Helicon Ltd

11th May 2014

Observations

Cracking in masonry at West end of building

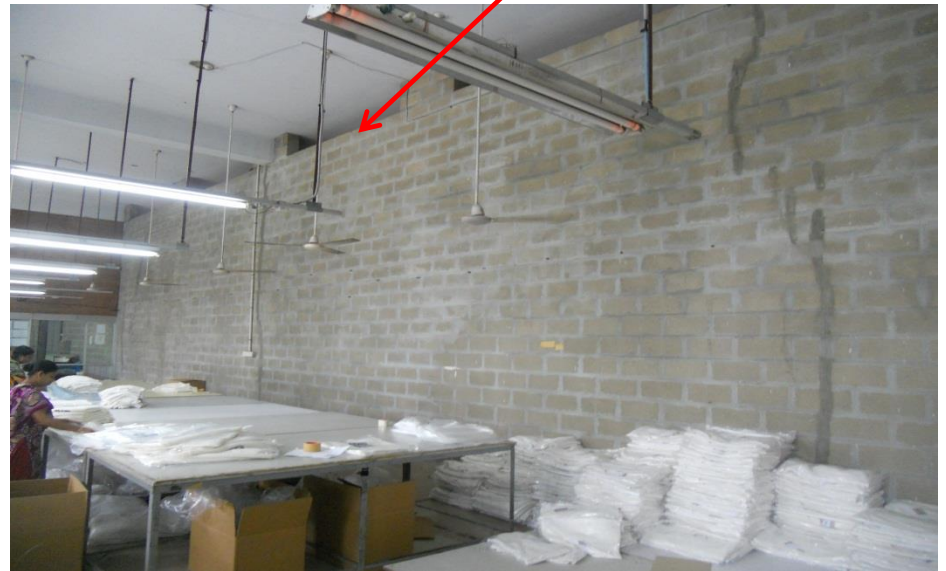
Significant cracking was noted in masonry walls along Grid 1 and 3 between Grids A and B at Level 2.

Cracking may have been caused by thermal movement in the structure or by foundation settlement.

Cracking in Ground Floor Slab

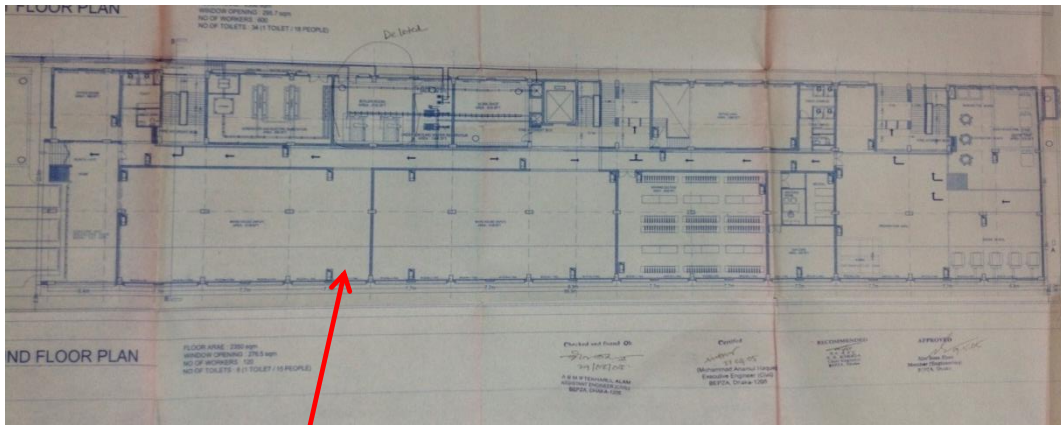
Cracks visible in exposed concrete areas (where no finishes exist)

Crack over ground tie beams

Cracks along lines of ground beams may be the result of settlement of the filling under the floor slab.

Cracking is visible in areas without floor finishes.
